COMM. NO.  
14132  
DATE:  
5/18/18

CLAUDE MOORE COMPLEX ADDITION  
**SEWER ADJUSTMENT  
RESOLUTION**

**XC102I**  
DRAWING NO.

**XC102J**  
DRAWING NO.

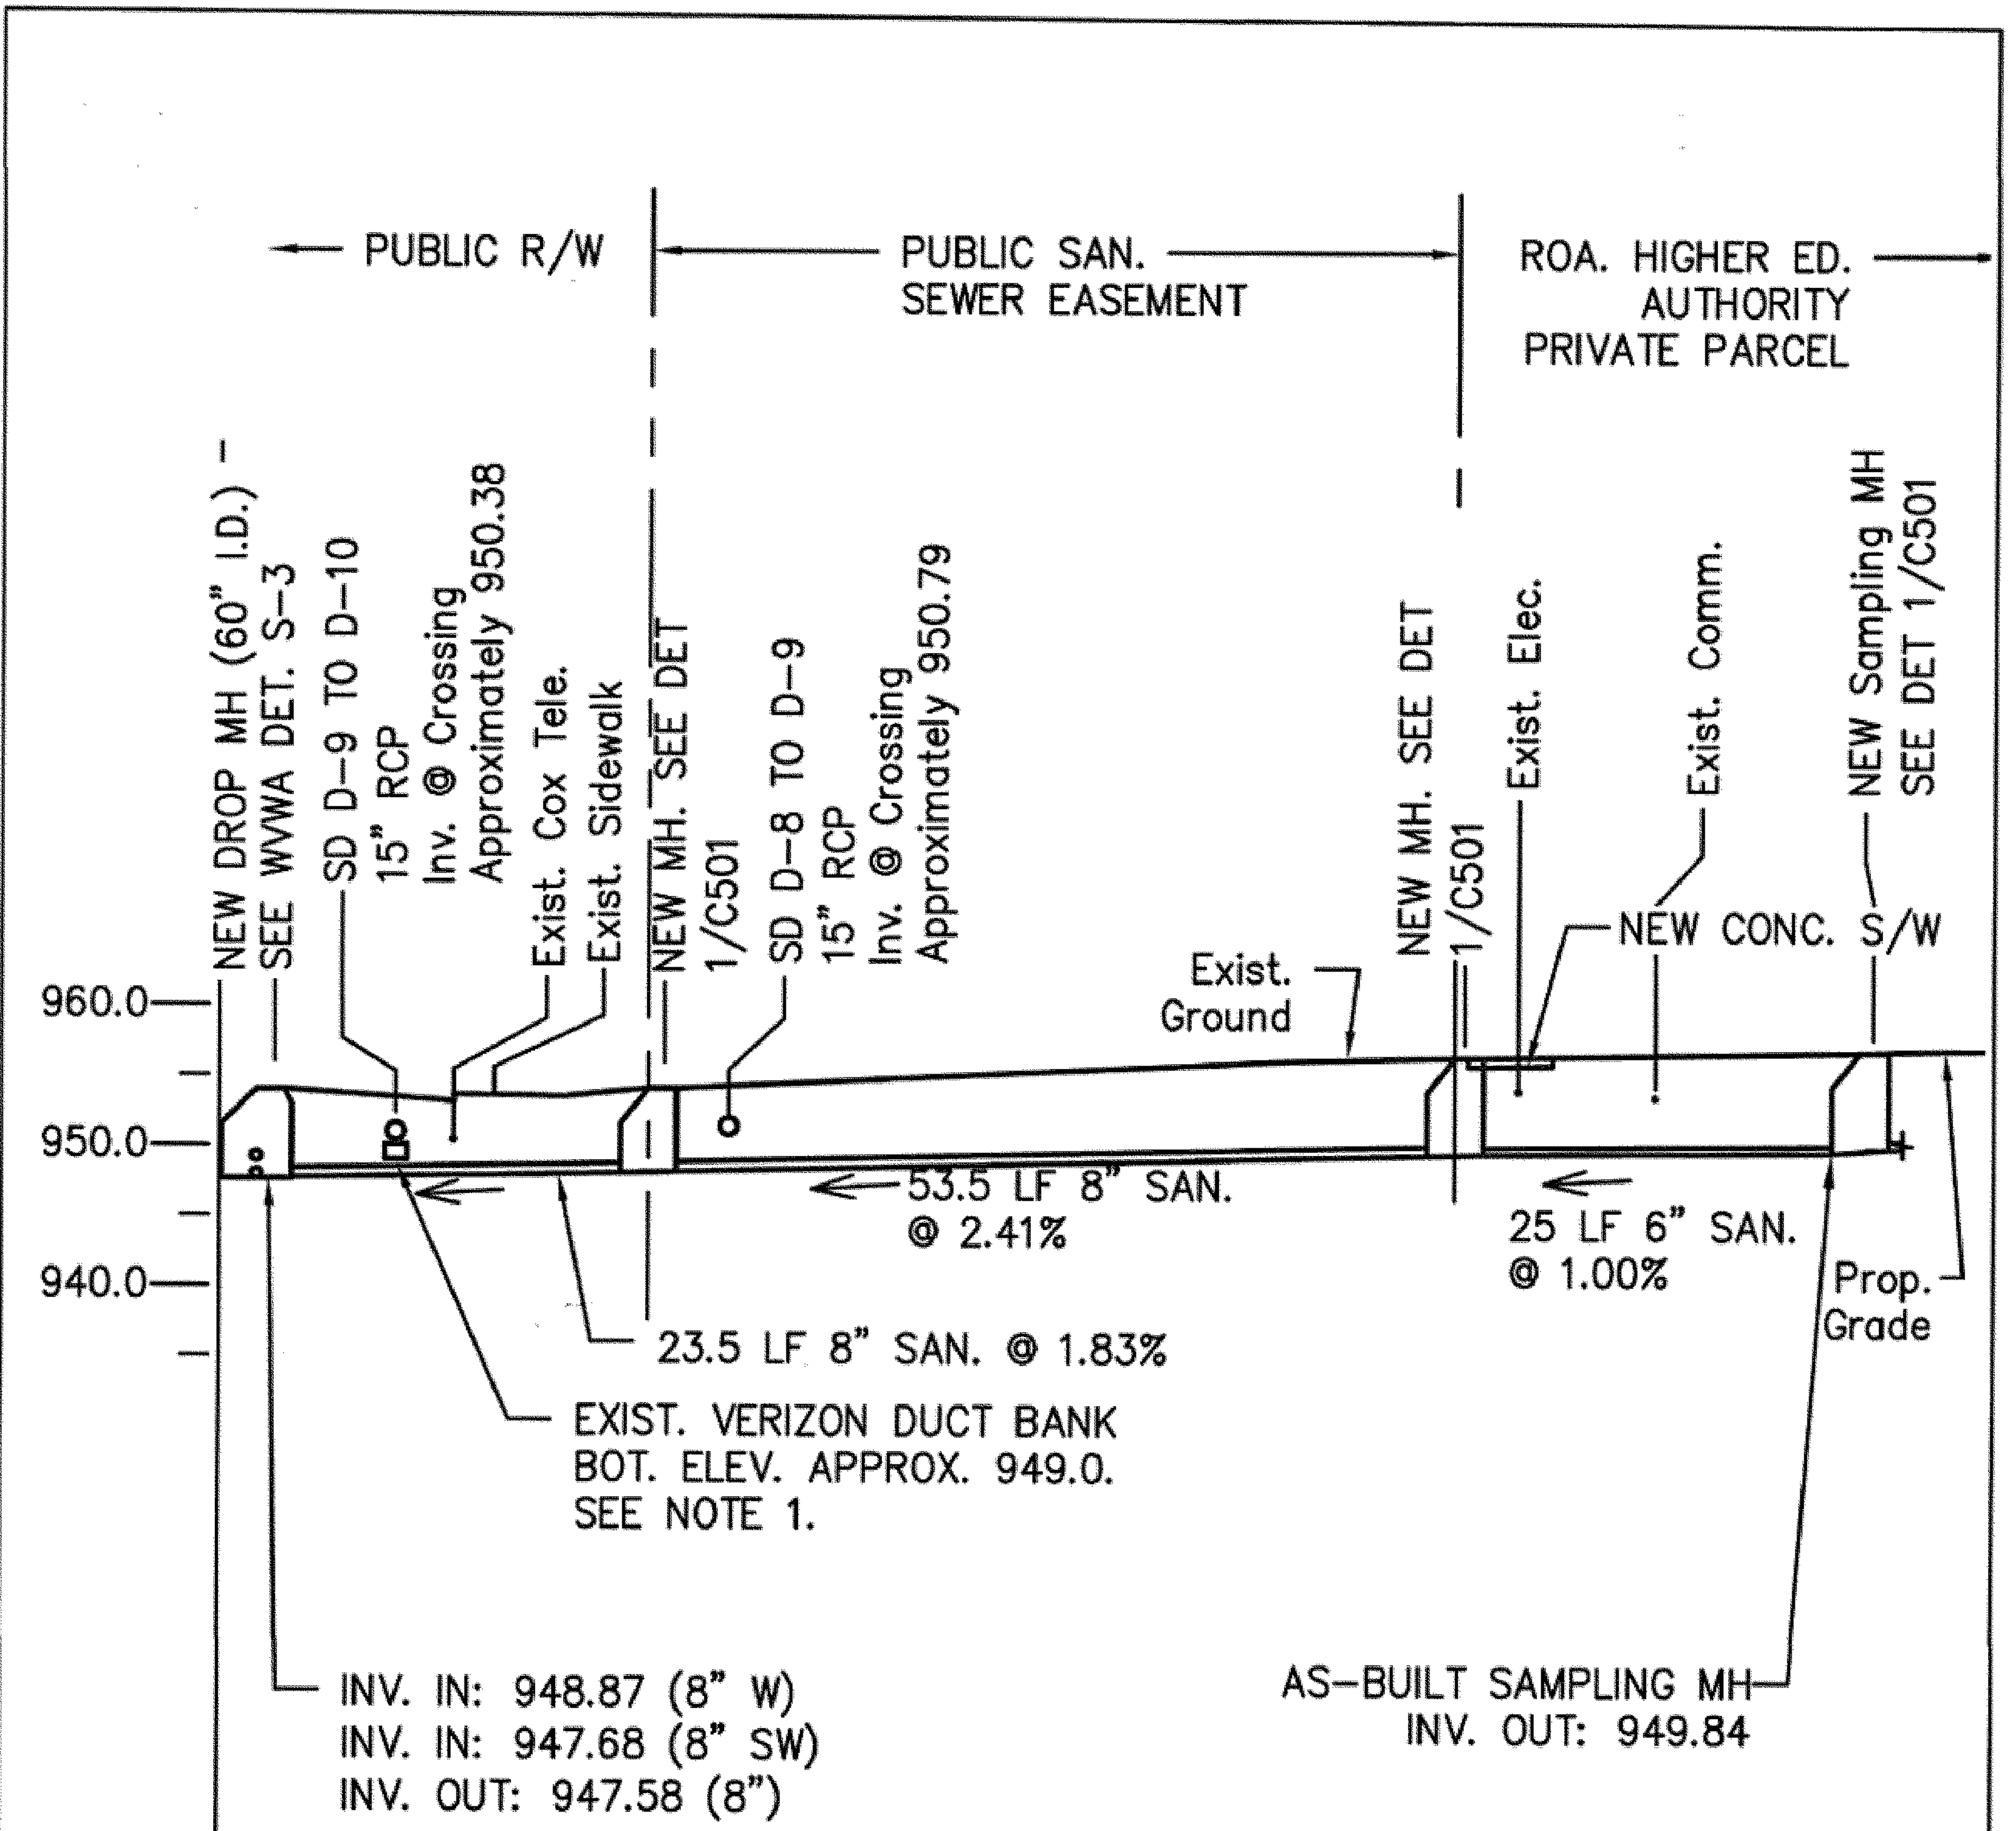
CLAUDE MOORE COMPLEX ADDITION  
**SEWER ADJUSTMENT PROFILE  
RESOLUTION**

- CONTRACTOR SHALL PROVIDE AND INSTALL PIERS AT SAN. SEWER/STORM DRAIN CROSSINGS AND SAN. SEWER/DUCT BANK CROSSING WHERE VERTICAL CLEARANCE IS LESS THAN 18". CONTRACTOR SHALL COORDINATE WORK WITH ASSIGNED WWA INSPECTOR MIN. 2 DAYS IN ADVANCE OF WORK.
